REGIONAL REVIEW NOTIFICATION

Name of Proposal: Strategic West Logisitics Center IV – Douglas Hills DRI 3515

Douglas County Natural Resources Group Review Comments January 31, 2022

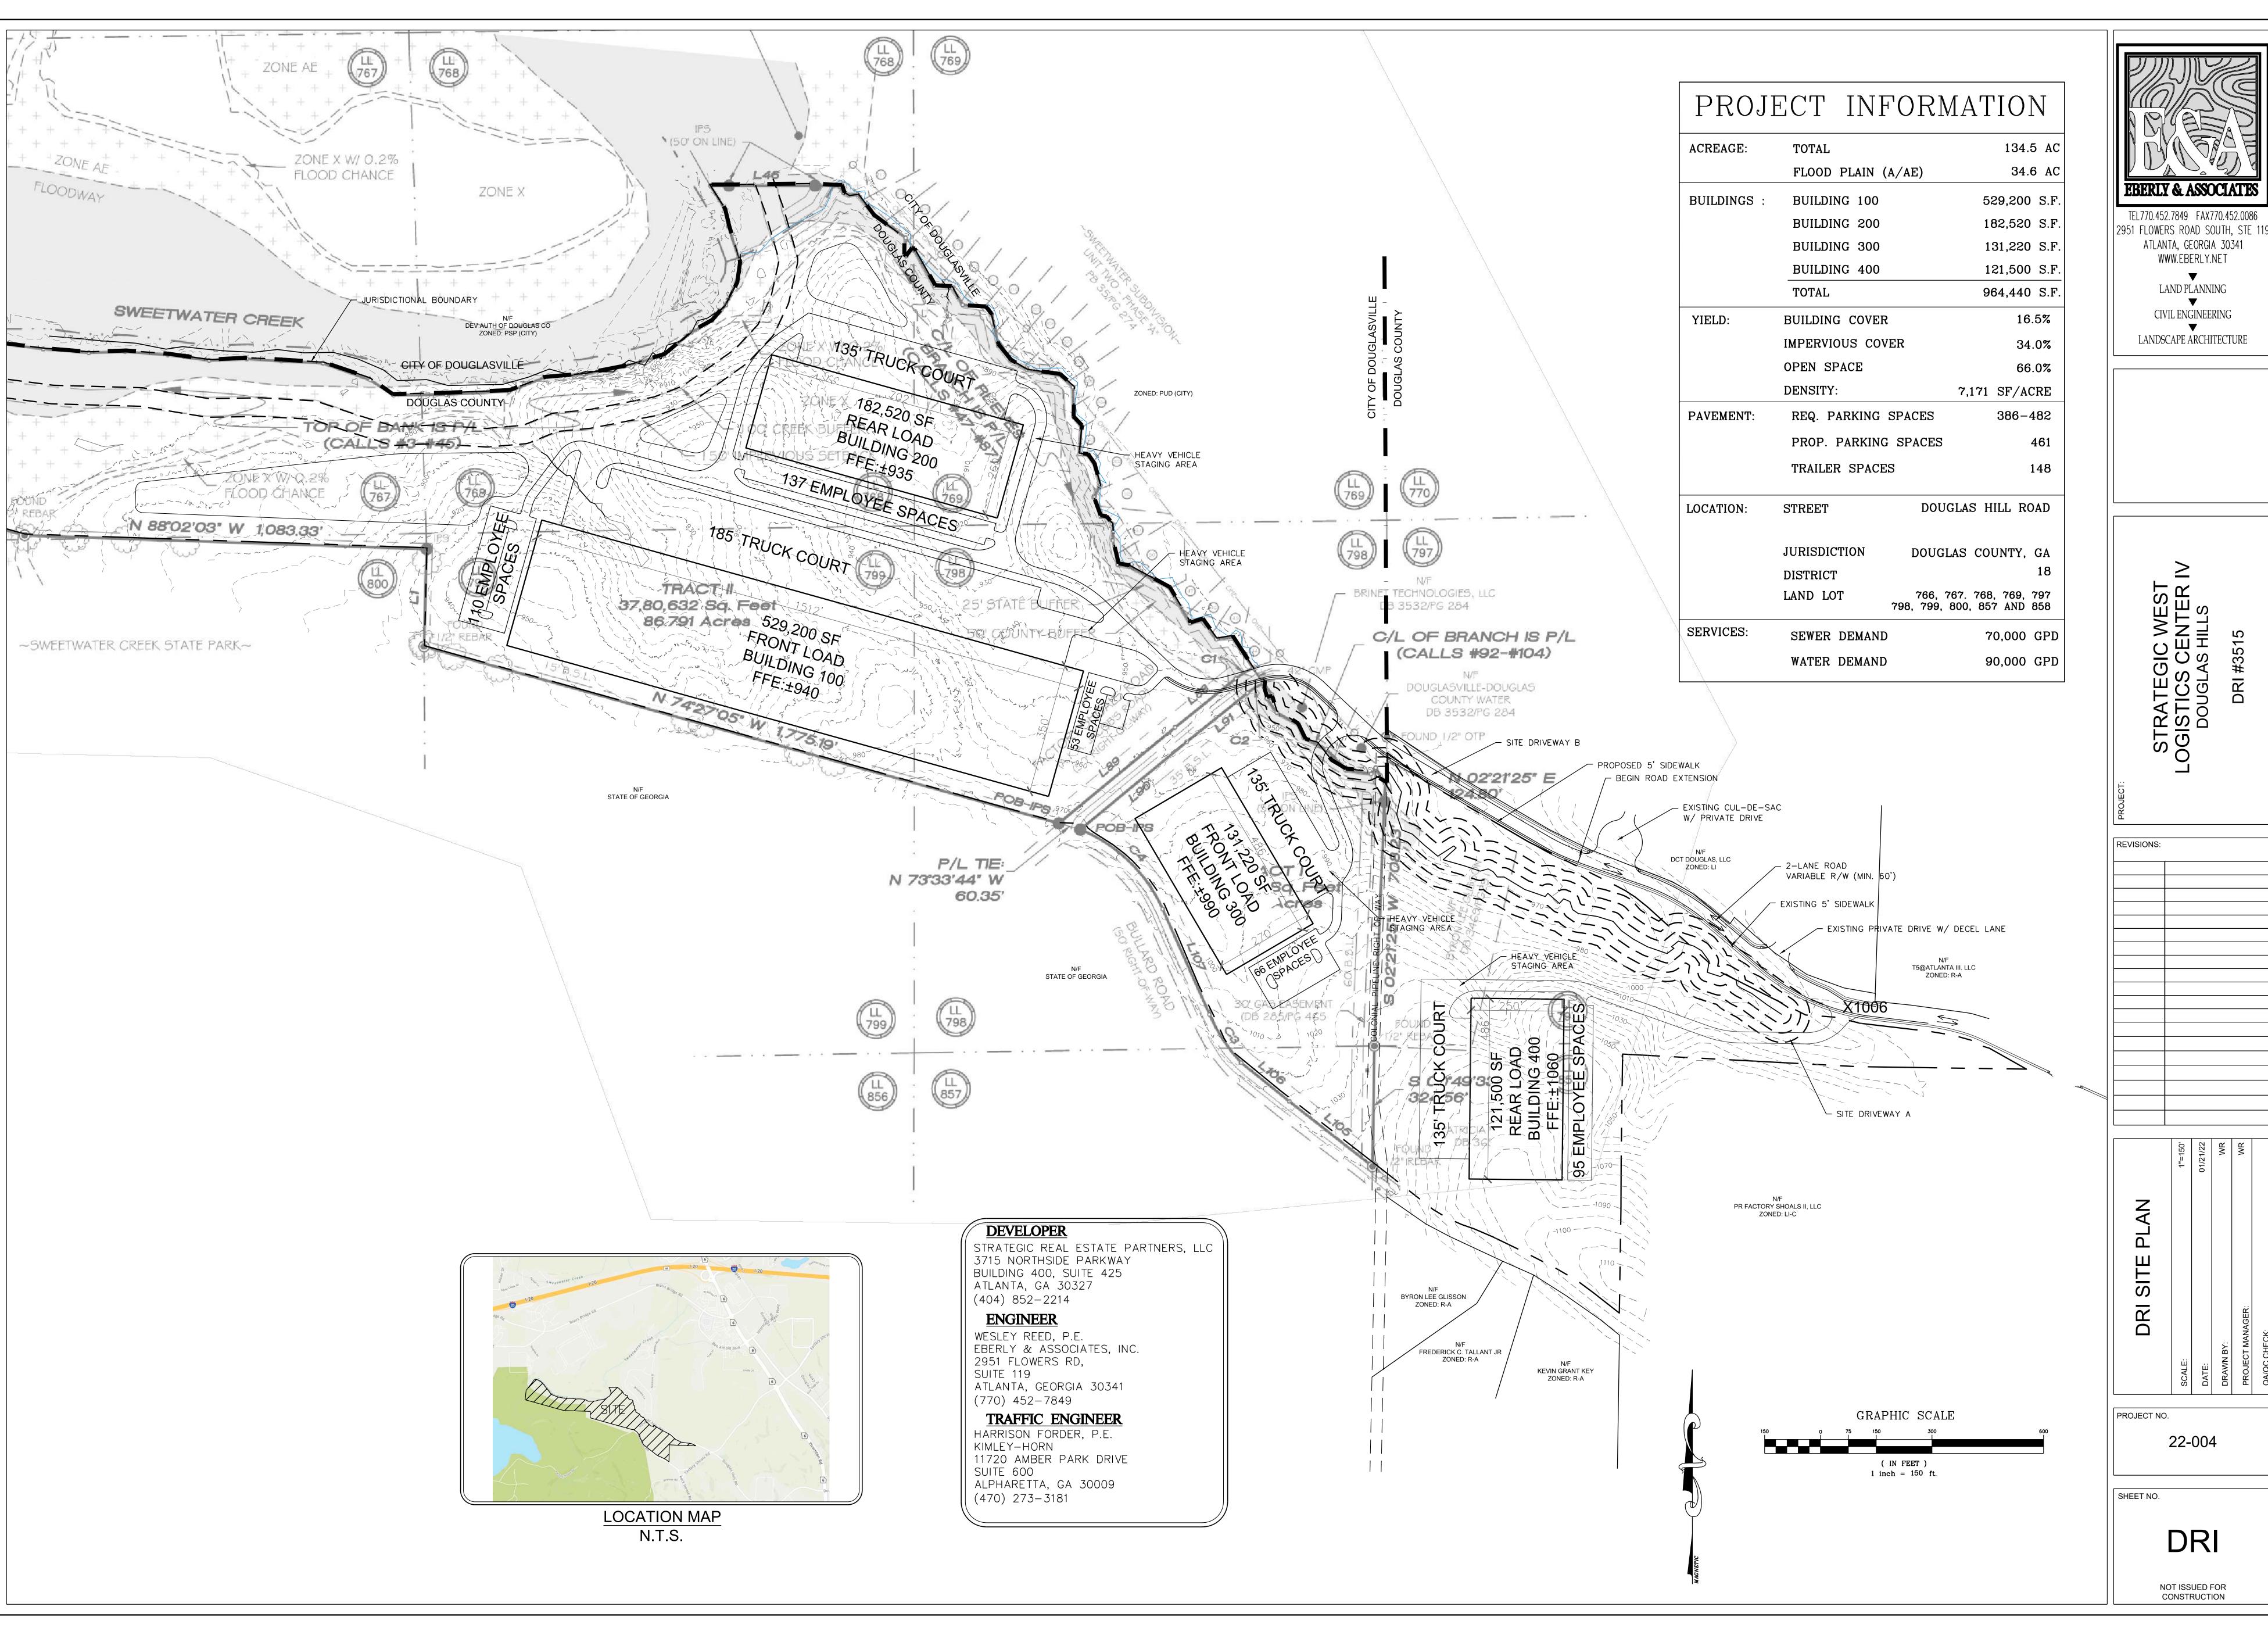
The USGS coverage for the project area and the submitted site plan both show Sweetwater Creek running along most of the northern boundary of the property. In addition, both the USGS coverage and the site plan show unnamed blue-line tributary to Sweetwater running along the northeastern portion of the property, starting entirely within the property boundaries and then running along the property boundary until it cuts across the northernmost portion of the property to flow into Sweetwater Creek. The site plan shows and identifies the 100-foot undisturbed buffer and additional 50-foot impervious surface setback required by the County along Sweetwater Creek. However, the State 25-foot State Erosion and Sedimentation Control buffer is not shown along Sweetwater Creek. Along the tributary, it appears that the 50-foot undisturbed buffer and additional 25-foot impervious setback required by the Douglas County Stream Buffer Ordinance and the State 25-foot State Erosion and Sedimentation Control buffer are shown but not identified between the tributary headwaters and the point where an unnamed two lane road crosses the stream. Between that point and Sweetwater Creek, the 50-foout undisturbed buffer and the State 25-foot buffer are shown and identified, but the additional 25-foot impervious surface setback is not shown. The site plan shows driveways to Buildings 300 and 400 as well as the unnamed two lane road crossing the stream buffers. The plan also shows a portion of a driveway and part of the driveway to Buildings 100 and 200 as well as a portion of the Building 200 truck court also intrude into the tributary stream buffers. Also, a drive accessing the Building 200 truck court and an unnamed area that may be stormwater detention run up to the edge of the Sweetwater Creek 150-foot setback.

All buffers need to be clearly identified, the 75-foot setback needs to be shown all along the tributary to Sweetwater and the 25-foot State Erosion and Sedimentation buffer needs to be shown along Sweetwater Creek.

All intrusions into the buffers may require variances under the both the County Stream Buffer Ordinance and the State 25-foot State Erosion and Sedimentation Control buffer. Any unmapped streams on the property may also be subject to the County buffer ordinance. Any unmapped State waters identified on the property may also be subject to the State 25-foot Sediment and Erosion Control buffer.
